Re-Bid Pre-Bid Addendum #1

Sheet Title
FIRE ALARM PLANS

Sheet No.
E-5
CONSTRUCTION DOCUMENTS

FIRST FLOOR FIRE ALARM PLAN - BASE BID 1
1/4" = 1'-0"

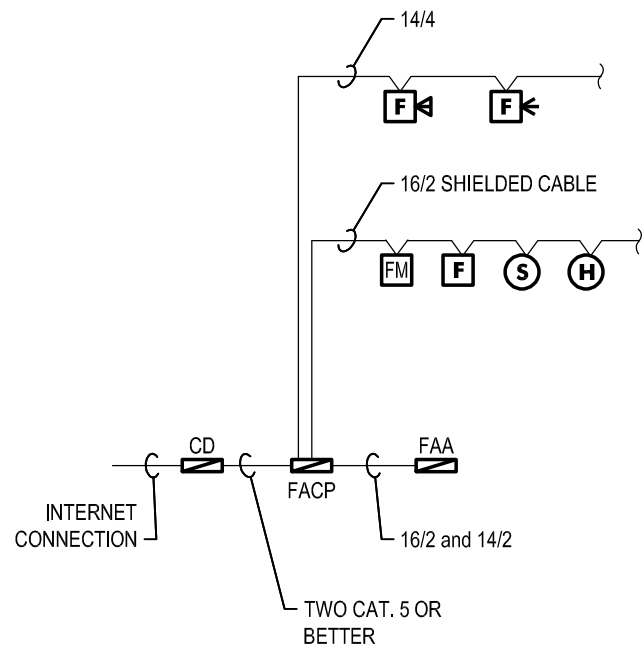
2. **Add** Drawing E-5 Fire Alarm Plans.
